## SERVICE BULLETIN NO. MSB 315-76/1 SERVICE BULLETIN NO. MSB 869-27/1

#### 1.4 Subject:

ATA-Code:                      27-60  
   Airbrake Control

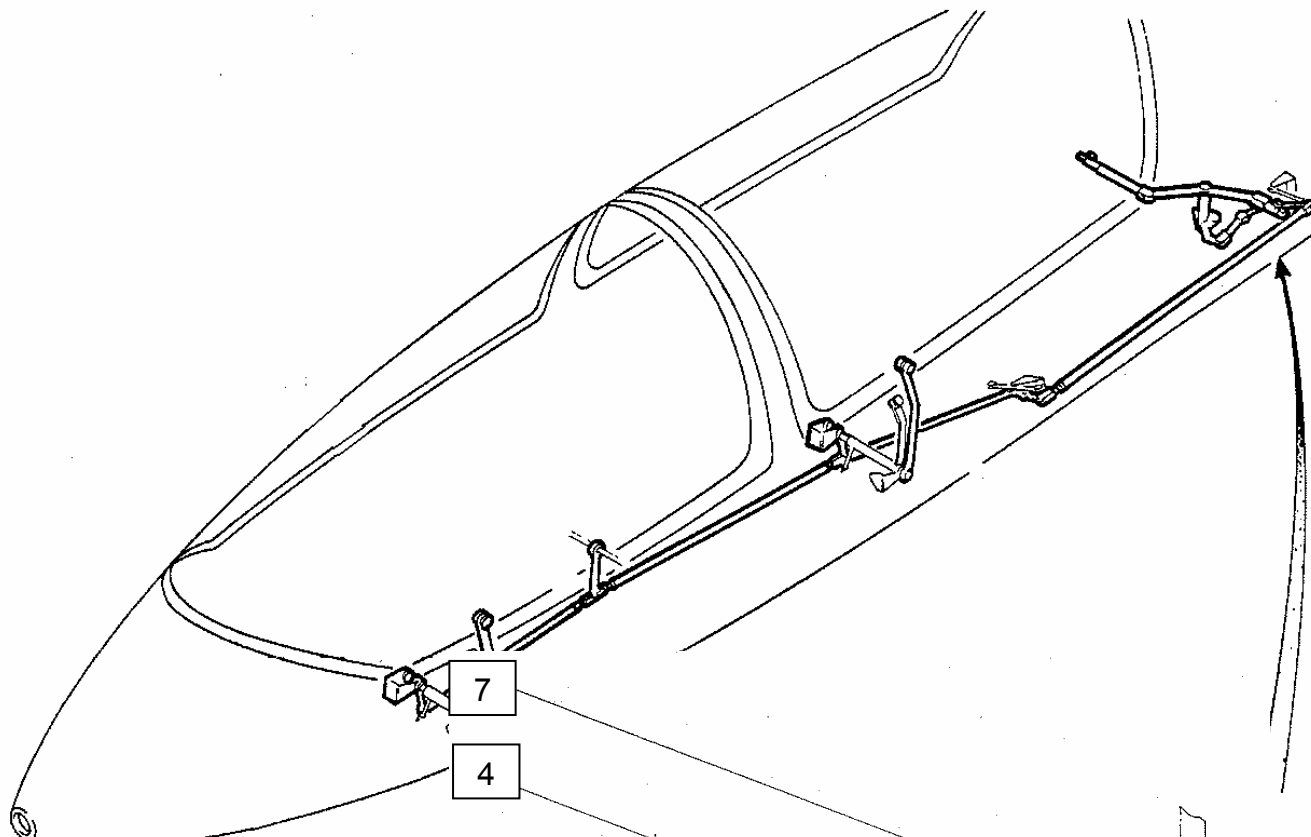
- 1.8.1 De-rig aircraft.
- 1.8.2 Remove rear seat.
- 1.8.3 Remove inner main wheel fairing.
- 1.8.4 Remove access cover behind the rear seat.
- 1.8.5 Remove bolt LN9037-M6x60 from the airbrake bell crank 103B-4437 and install new bolt. Use new locking nut LN9348-M6 (see figure on page 4). Bolt torque: 6.4 Nm (4.72lbs.ft)

Note: Alternatively bolt LN9037-M6x62 may be installed. Thereby use additional washer LN9037-6,4 under the bolt head.

- 1.8.6 Check visually all parts of the airbrake bell crank including the attachment parts for any damage (if required use magnifying glass 10x). Damaged parts must be replaced (see also table on page 4).
